Civic Design Review Submission Materials

Bartram Village I
2639 South 58th street
Philadelphia, Pennsylvania 19143
June 4, 2024

BARTRAM VILLAGE 1, LLC
BARTRAM VILLAGE I
 2639 SOUTH 58TH STREET, PHILADELPHIA, PA 19143
**GARBAGE TRUCK
 TURNING PLAN**

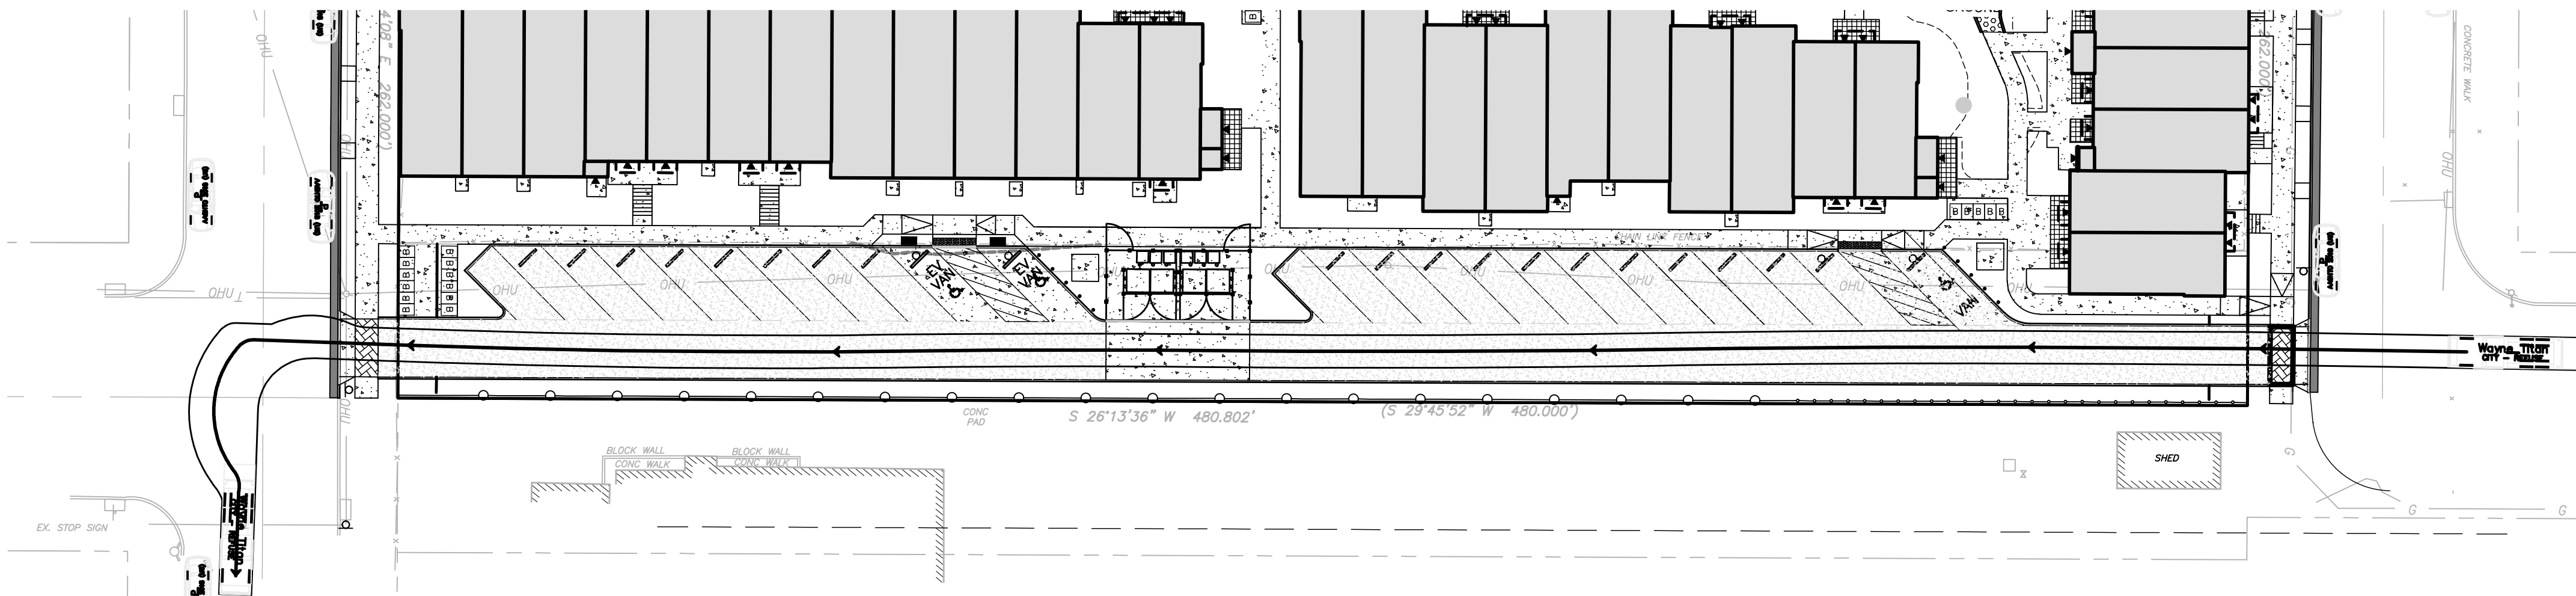
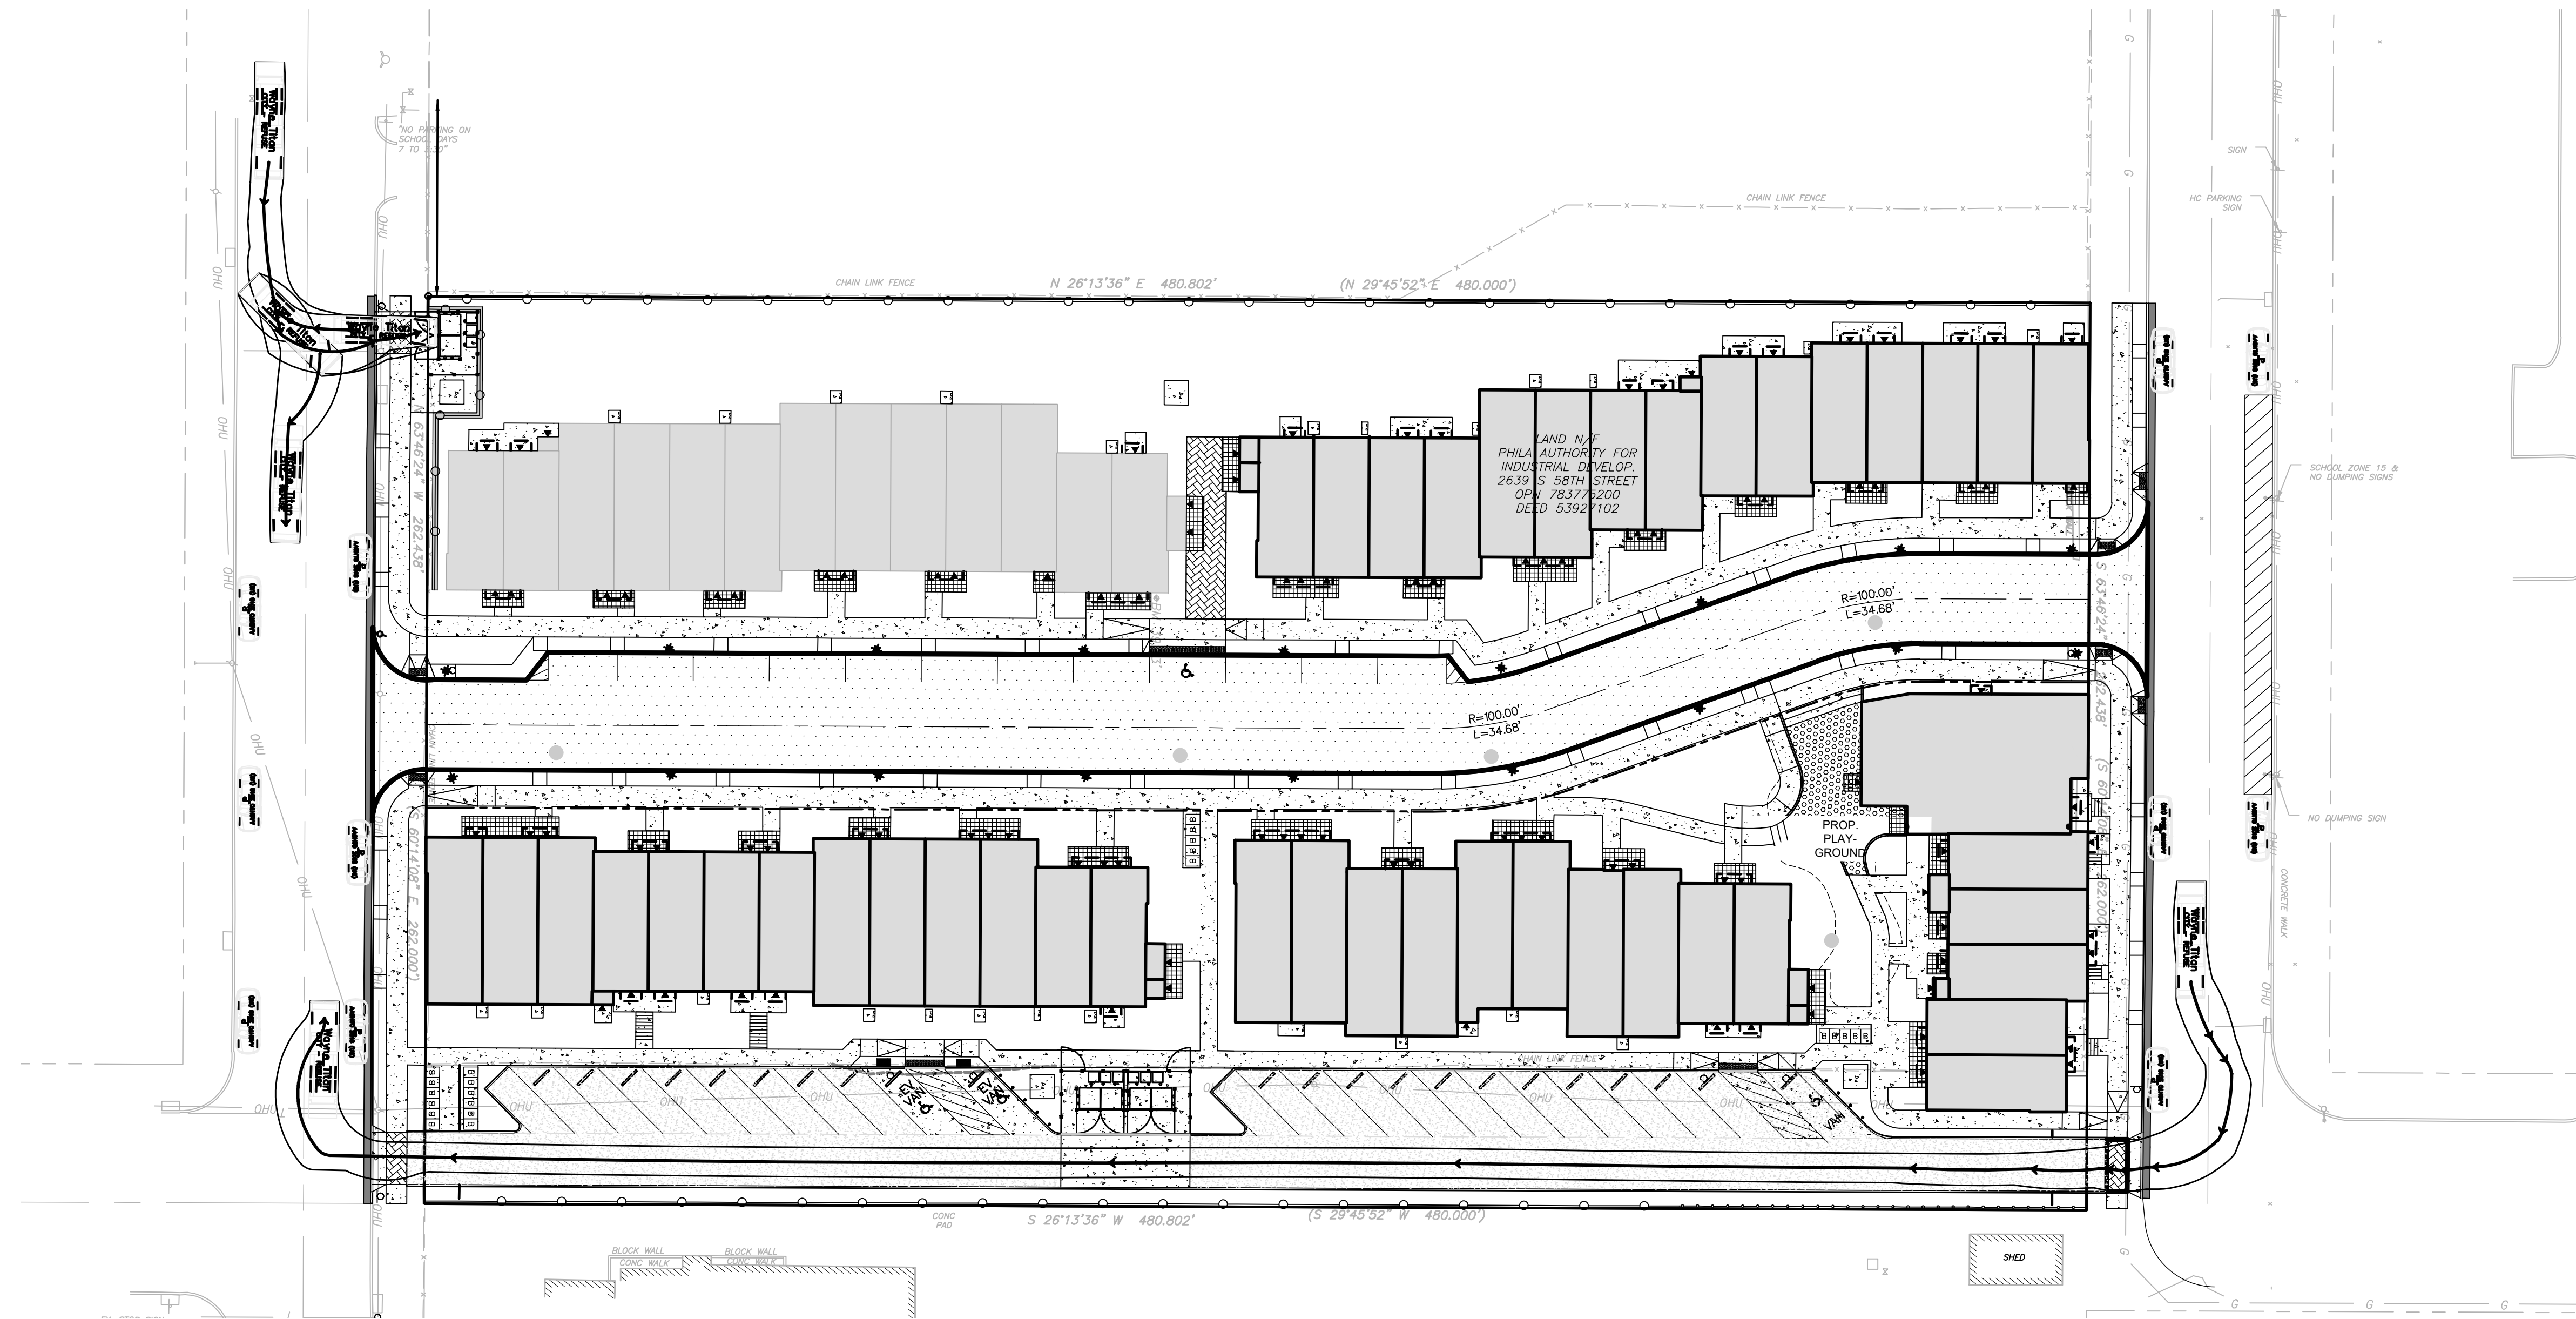
Please ensure that trash pick-up area on 58th St is secured and fenced off to prevent illegal dumping. Also provide turning templates for trash pickup and all vehicular movements.

PROPOSED ILLUSTRATED SITE PLAN

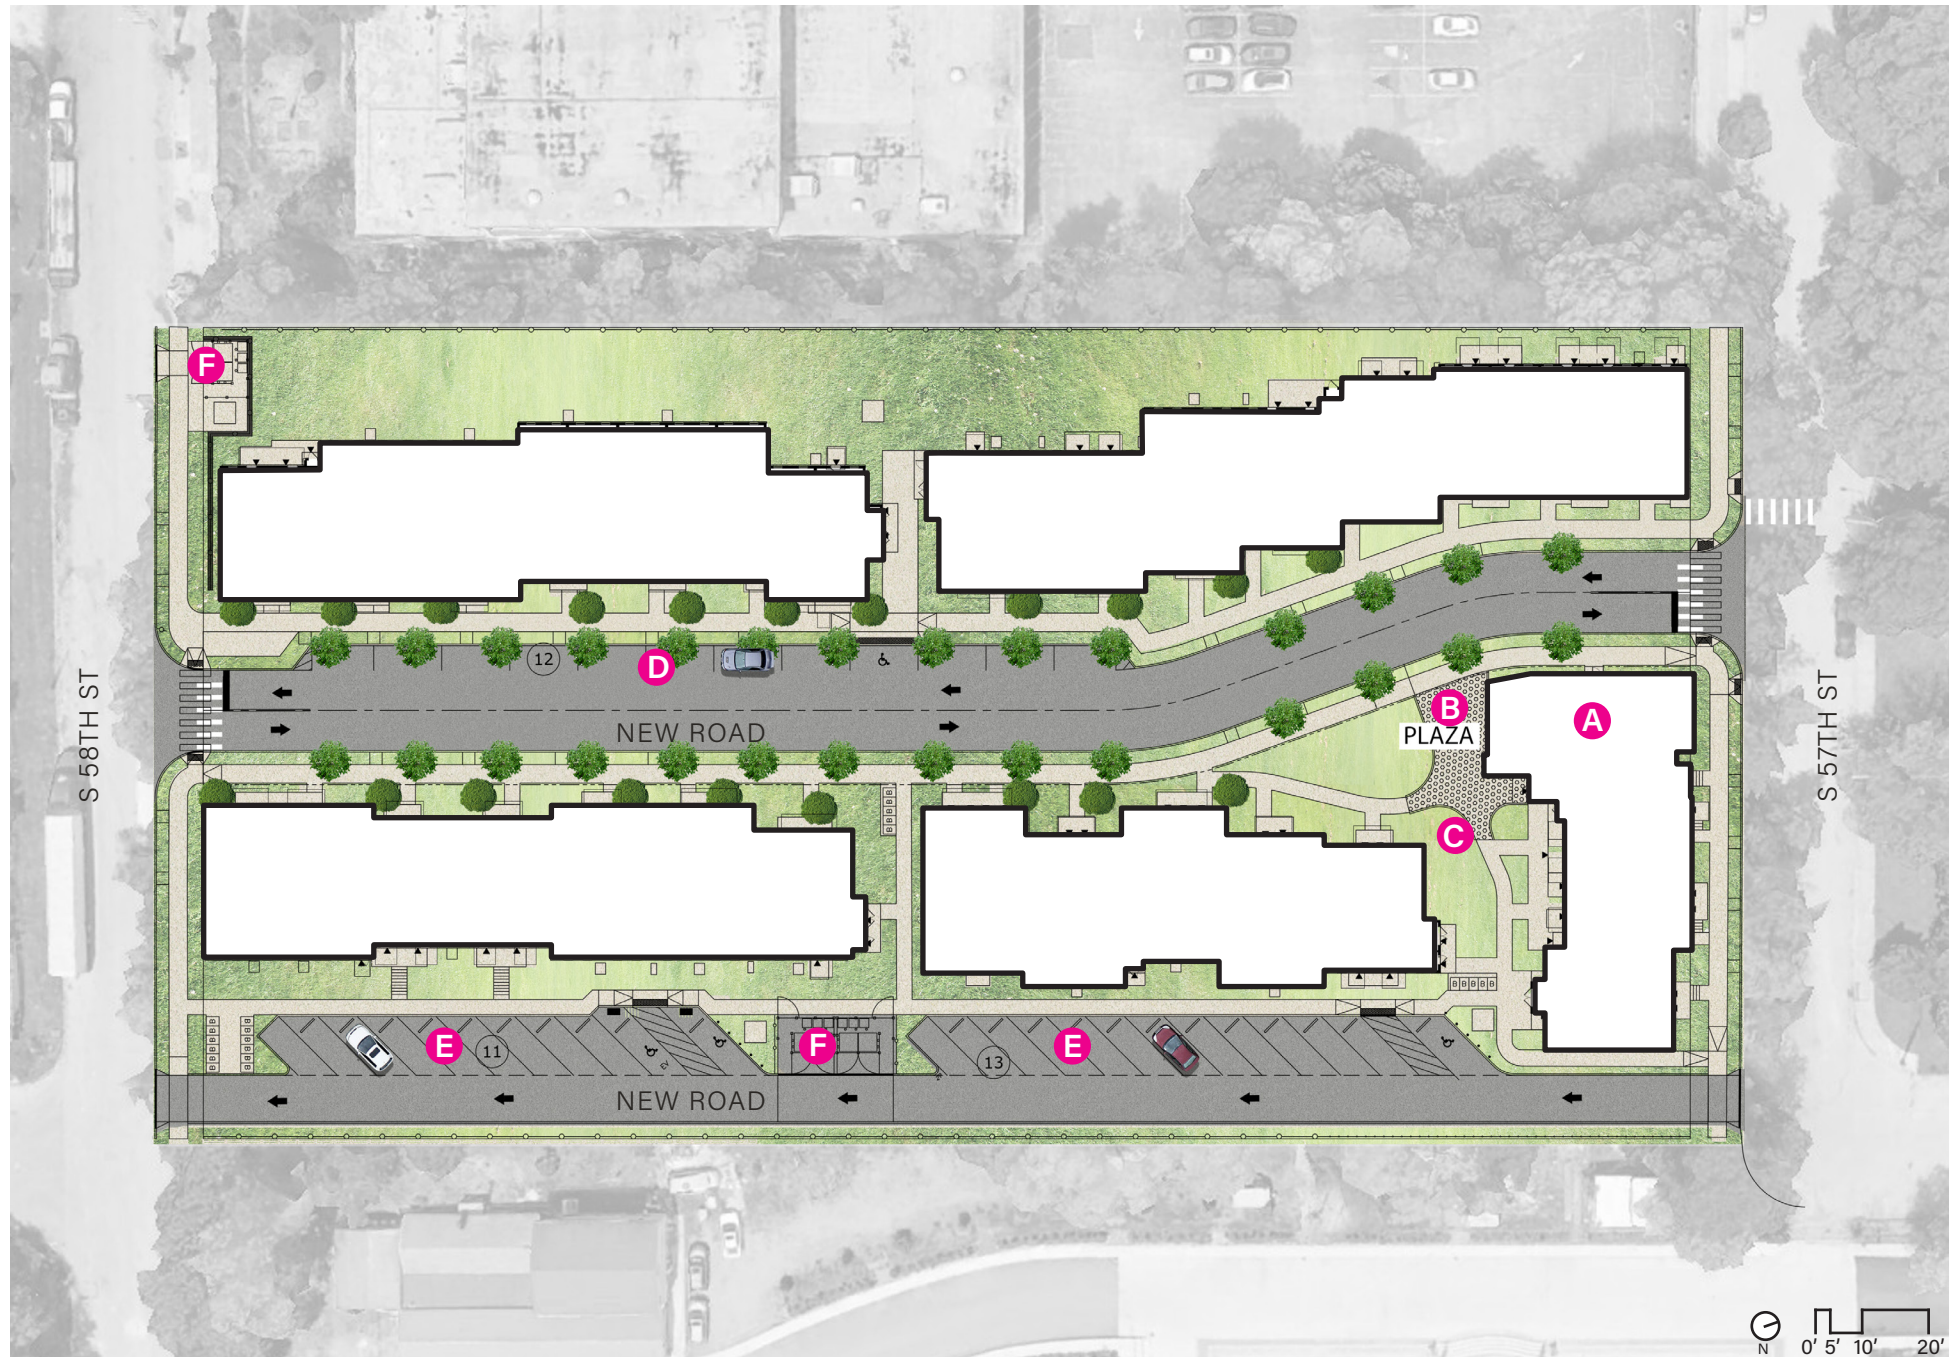
Will the triangular plaza between buildings 3 and 5 be landscaped with greenery or remain bare concrete? Please include a proper landscaping plan and ensure an accessible route is maintained to the playground and to the rear parking area.

Are there fences planned on the east/west/south borders of the property on top of the retaining walls? Please indicate clearly in the renderings and site sections. If there are, please refrain from using chain-link fences.

PROPOSED ILLUSTRATED PLAY AND PLAZA PLAN

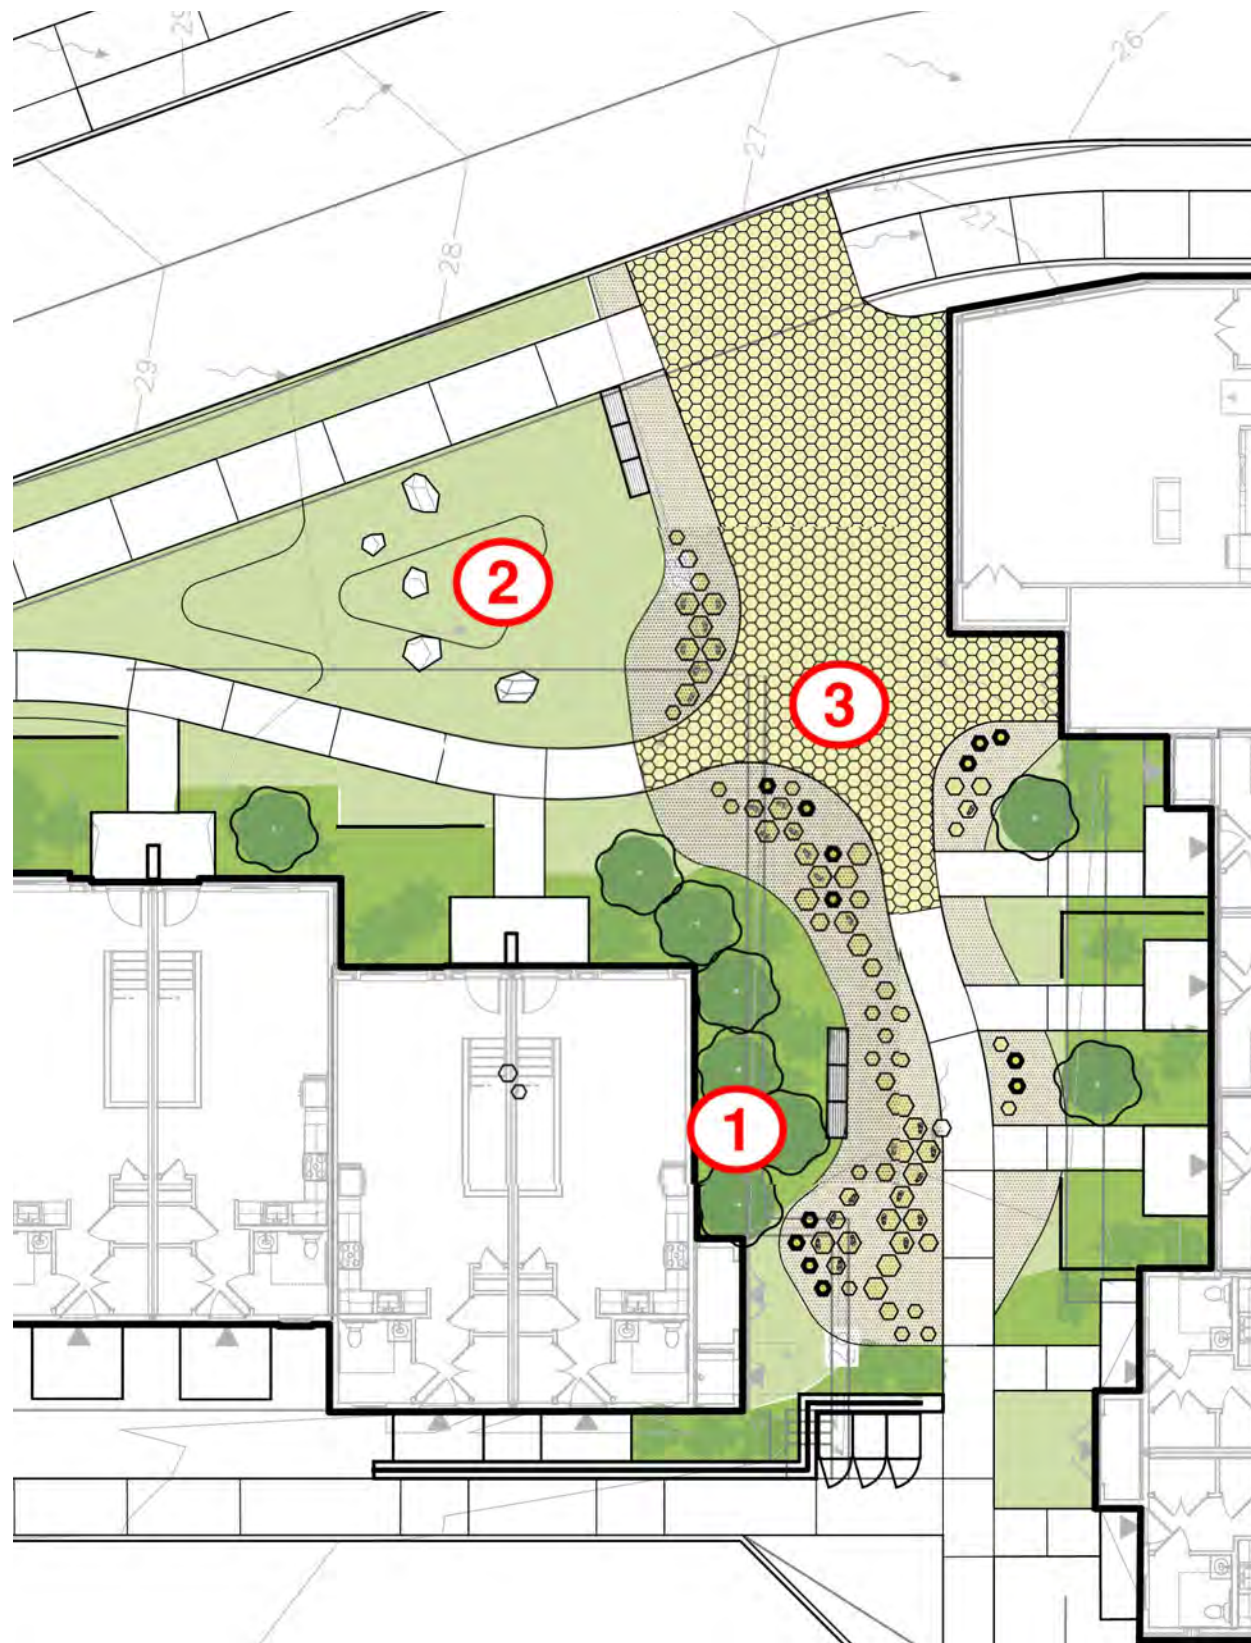
6	<p>Play Area/Plaza could be a richer experience.</p> <p><i>The Development team will provide additional visuals and details about enriching the Play Area/Plaza.</i></p>
7	<p>Front yards and covered entries could be used as community spaces – lean into opportunities for informal gathering spaces with landscaping and texture.</p> <p><i>The Development team will explore opportunities for additional community spaces. An important aspect of this community is that the residents have their own front door, creating “stoop mentality.” Additionally, there is a community space on site with an accompanying outdoor gathering space.</i></p>
8	<p>Design of the new street:</p> <ul style="list-style-type: none"> - There will be mid-block crossings – the street should be designed for this. - The parking lane should use a different material than the driving lane. - Since this is a new street and there will not be overhead wires – aim to make it as green as possible - space trees 15 feet on center. <p><i>The Street design will be reviewed by the Streets Department, whose requirements must be complied with during the Building Permit process.</i></p>
